PROPOSED REVISION  
**DUNDAS COUNTY ROAD NO. 8**  
(CHURCH STREET)

WILLIAMSBURG TWP. BRIDGE N°5

REVIEW OF PRELIMINARY PLAN

Re: Williamsburg Twp. Bridge #5,  
Hwy. #401, District #9,  
W.P. 137-59.

DEPARTMENT OF HIGHWAYS BRIDGE OFFICE - TORONTO			
WILLIAMSBURG TWP. BRIDGE			
THE KING'S HIGHWAY No. 401 CO. DUNDAS TWP. WILLIAMSBURG Lot 18 & 19			
PRELIMINARY PLAN			
APPROVED			
BRIDGE ENGINEER			
DESIGN	AR	CHECK	CONTRACT NUMBERS
DRAWING	GP	CHECK	LOADING
TRACING		CHECK	DRAWN BY
DATE	DEC. 60

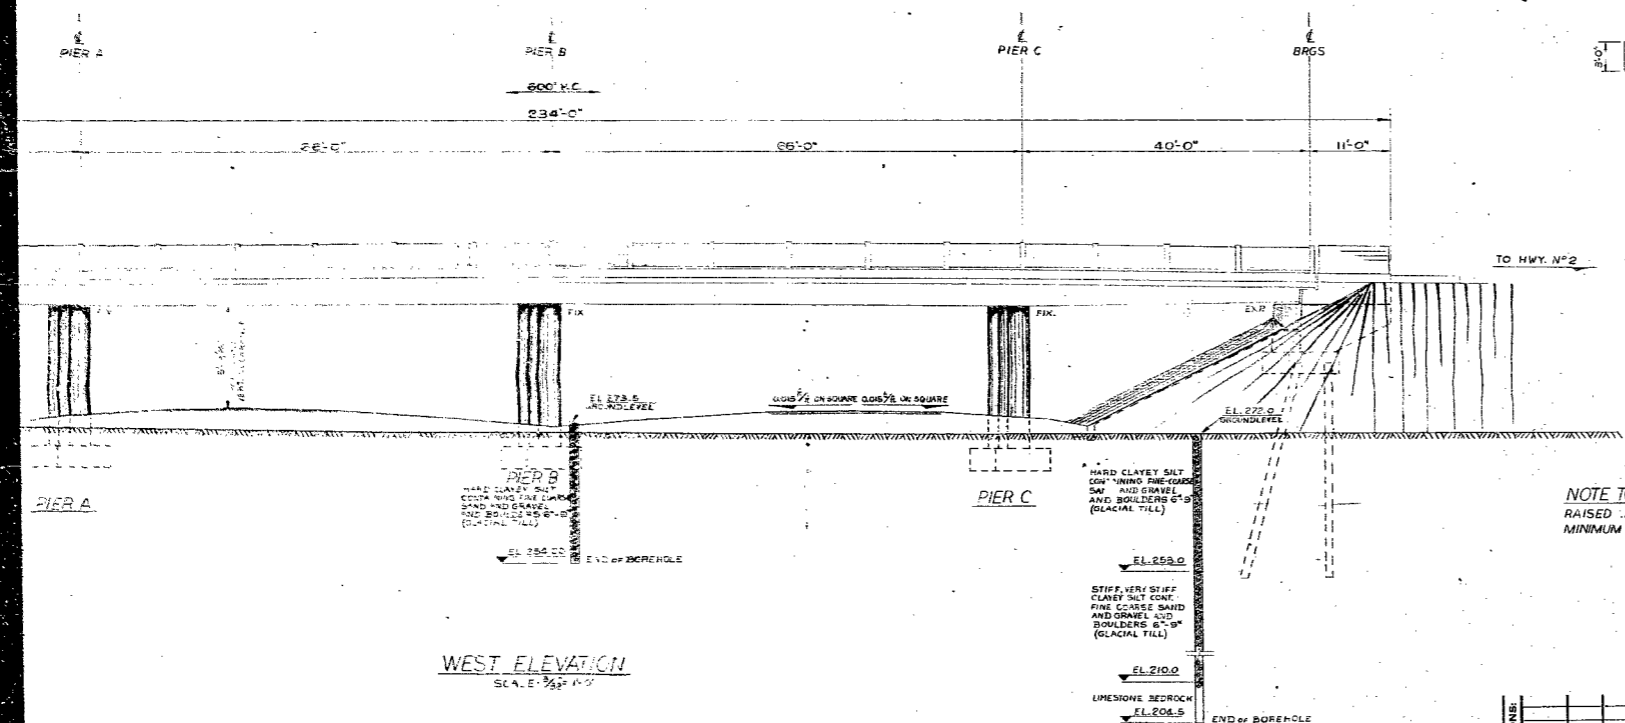
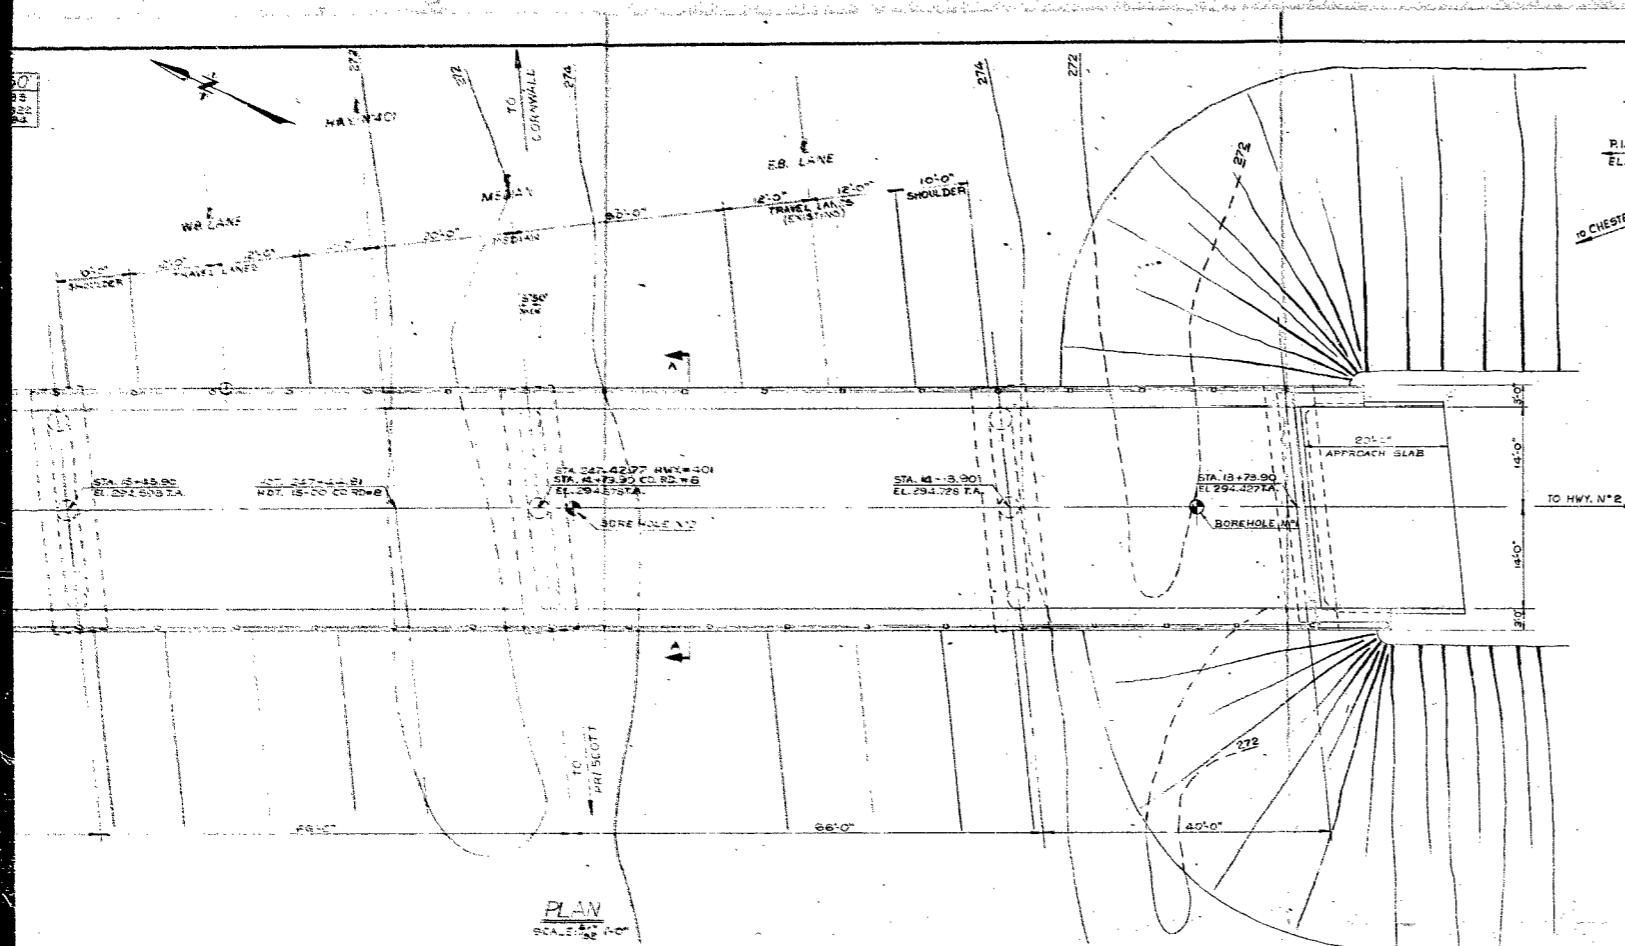
NOTE TO ROAD DESIGN: GRADE OF CO. RD. N° 8 RAISED .34 BY BRIDGE OFFICE TO ALLOW FOR MINIMUM VERTICAL CLEARANCE.

DESIGN AR CHECK CONTRACT NUMBER  
DRAWING GP CHECK LOADING  
TRACING CHECK  
DATE DEC. 60 DRAWING NUMBER D-4789-P

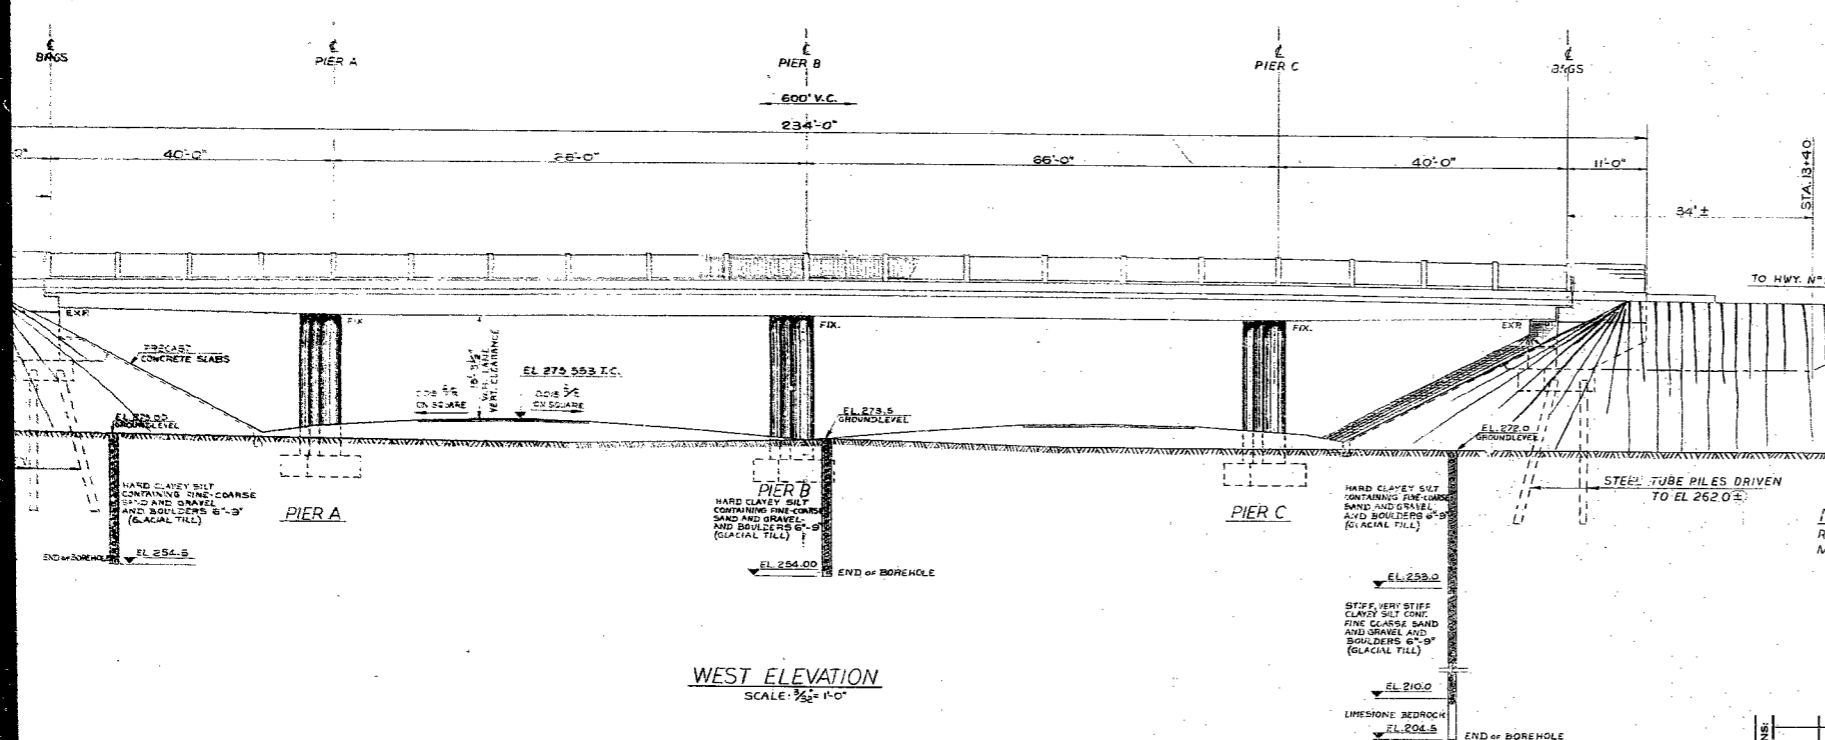
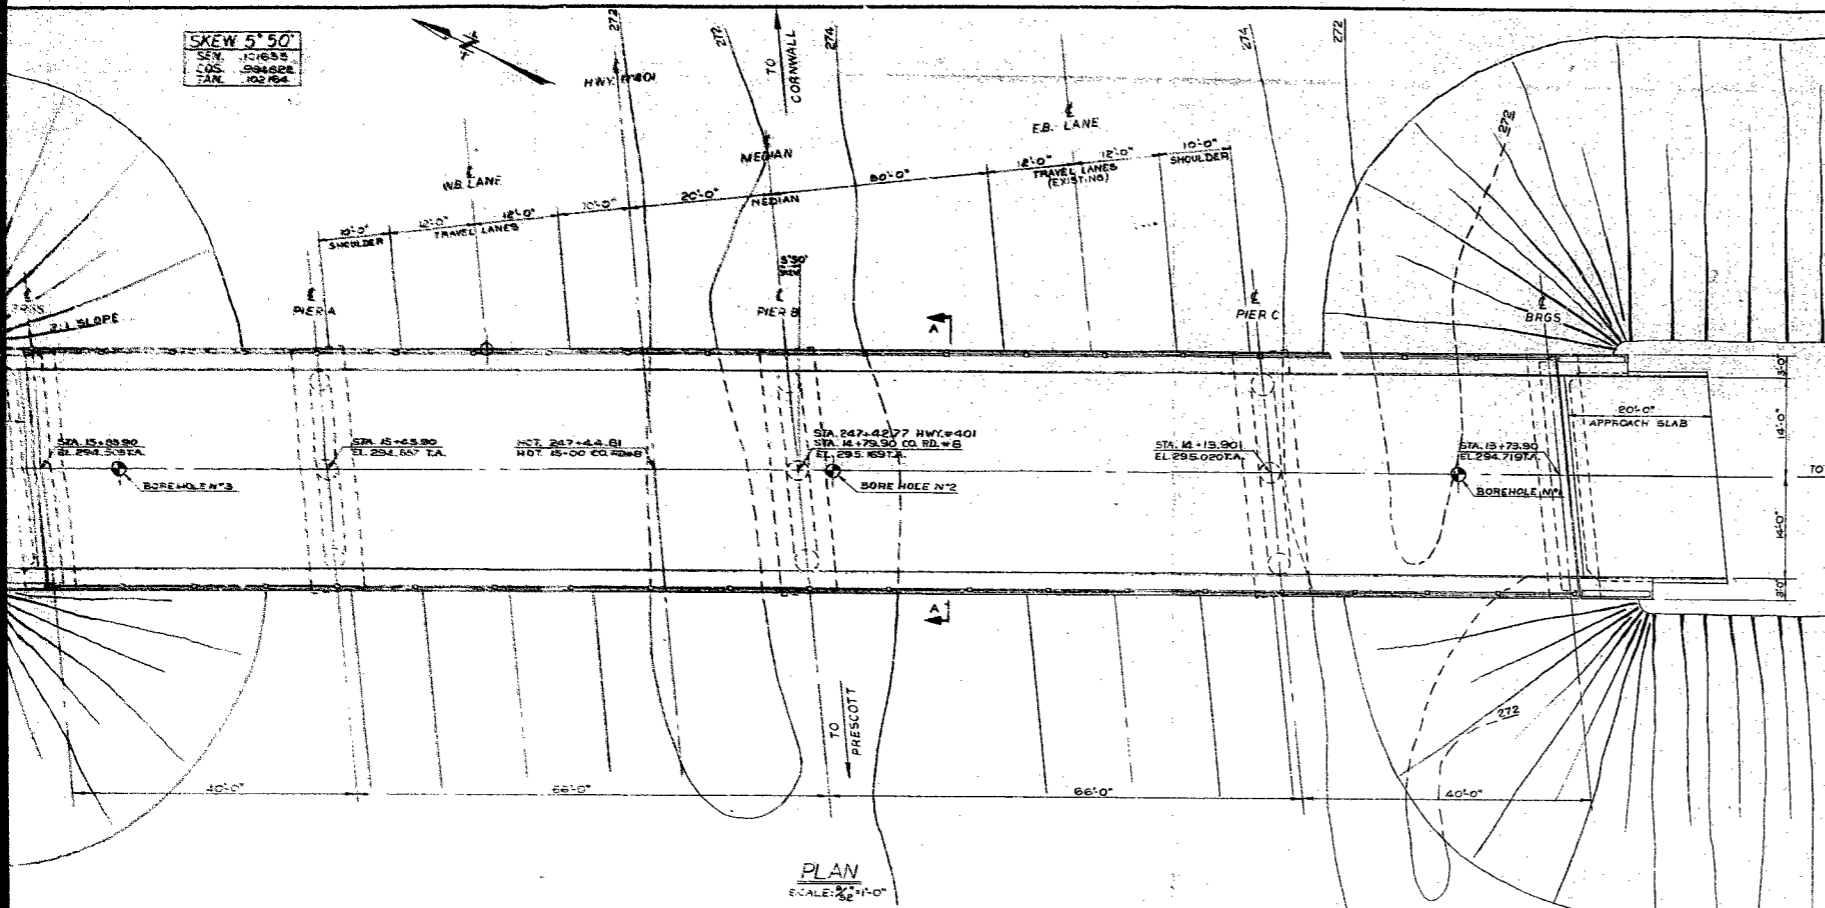
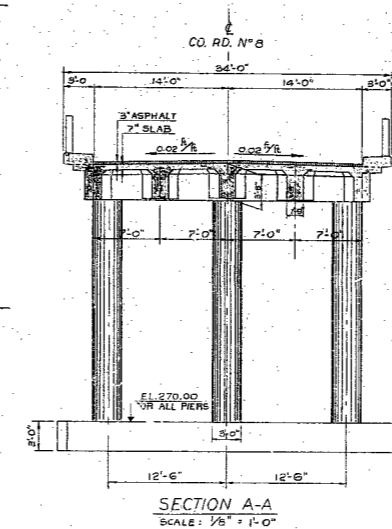
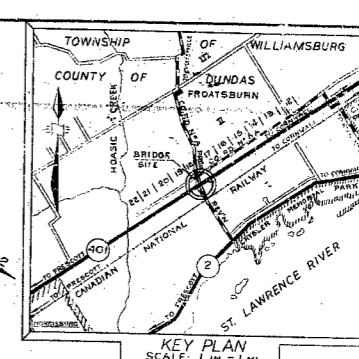
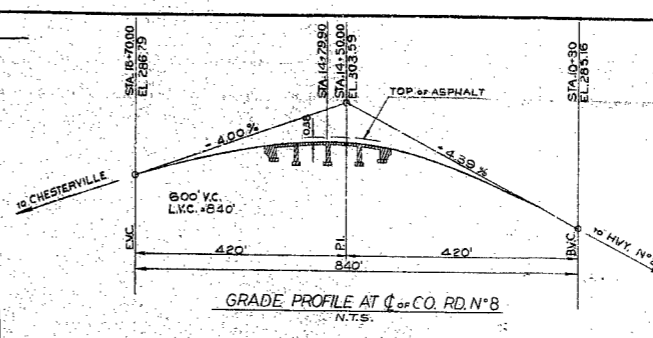
The soil report BA 1135 calls for spread footings for this structure. We would like to place the abutments on piles as indicated,

Kindly give us your opinion as to type, length and allowable design load for these piles.

If it is desired to place the abutments on piles  
as indicated on Drawing #D 4789-P, we would recommend that  
the approach fill consisting of granular material, be placed  
up to the elevation of the underside of the proposed abutment  
footings, and thoroughly compacted. Timber or tube displacement  
piles should then be driven through the fill down to elevation  
262.0'. It is emphasized that the piles should not penetrate  
beyond this elevation.

If this procedure is carried out, we would recommend  
a design load of 30 tons per pile.
